PCN no.: <b>PCN_167, rev. 1.0</b>	Date: <b>2022-06-07</b>	
Device affected: <b>nPM1100-CAAA</b>	Device version / Build Code: <b>Coo</b>	
Data sheet references: <b>N/A</b>	Agreement reference: <b>N/A</b>	Customers reference: <b>To whom it may concern</b>

**Description of change:**

Unexpected DCDC Converter shutdown eliminated. VOUTB overshoot during manual DCDC mode change eliminated. Customers who want to take advantage of the changes introduced in revision 2 (build code Eoo) will need to place orders via separate ordering code (nPM1100-CAAA-E). Production of revision 1 (build code Coo) will be discontinued according to the schedule specified below and is ordered using the existing ordering code (nPM1100-CAAA).

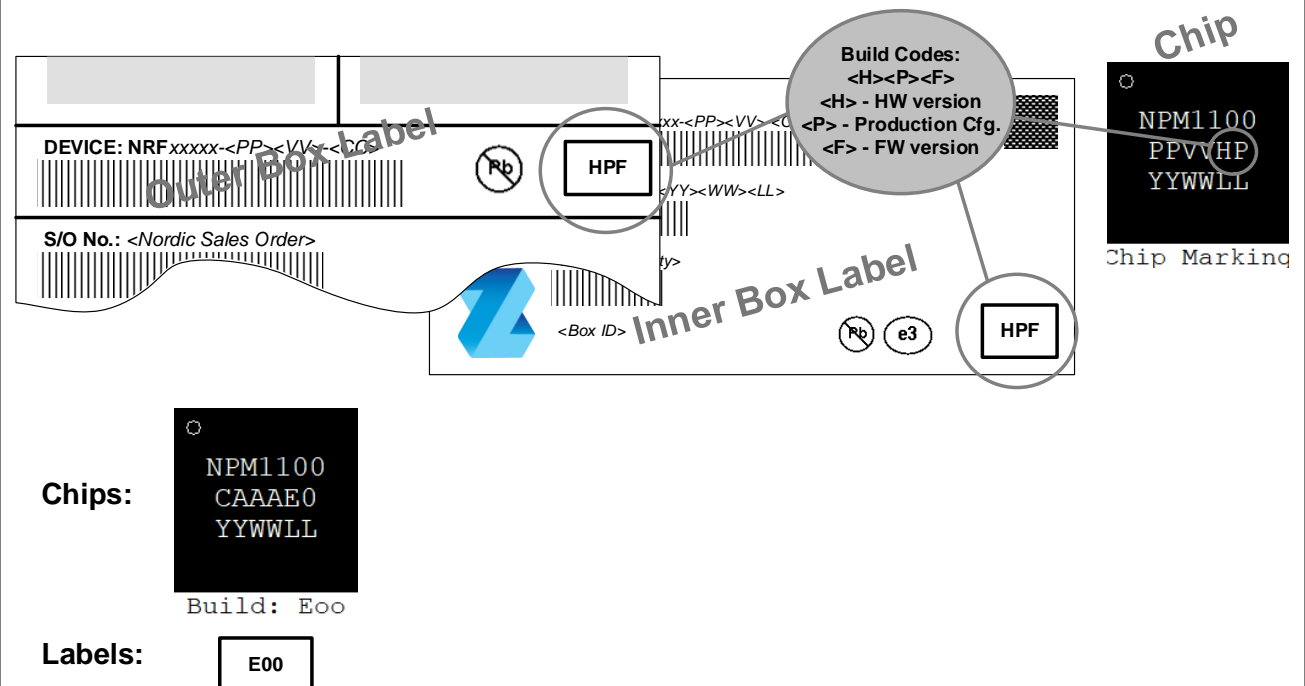
The new revision is recognized on shipping labels and chip marking as illustrated below:

Build code Eoo
